Advice on Assessment for Huntlee New Town - Stage 2 - Wine Country Drive, Rothbury

SSD-70748466 - Advice on RTS - Huntlee New Town - Stage 2 - Wine Country Drive Rothbury

RE: Review of Environmental Impact Statement (SSD-70748466) - Advice on EIS - Huntlee New Town - Stage 2 - Wine Country Drive Rothbury

Figure 8.7: Rural CHL treatment with an acceleration lane

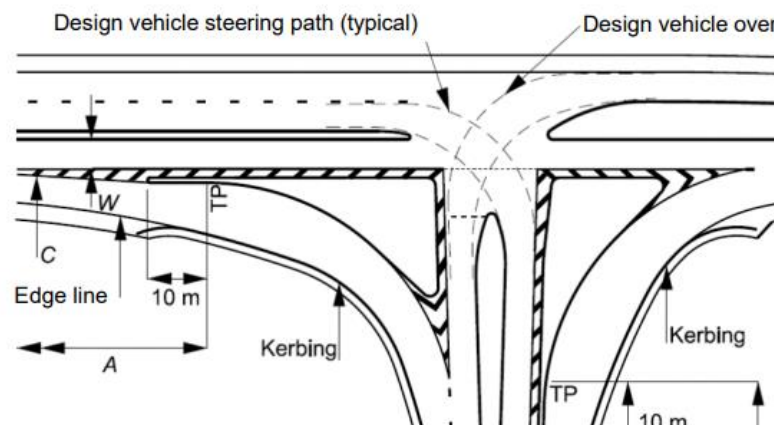
- Where the new slip lane joins the existing westbound highway entry ramp, the raised island nose should run parallel for 10m after the tangent to force a parallel merge in accordance with AGRD 4a figure 8.7. In this area, a space is also required for cyclist to cross with care. See image below titled 'Figure 8:7 Rural CHL treatment with an acceleration lane'.
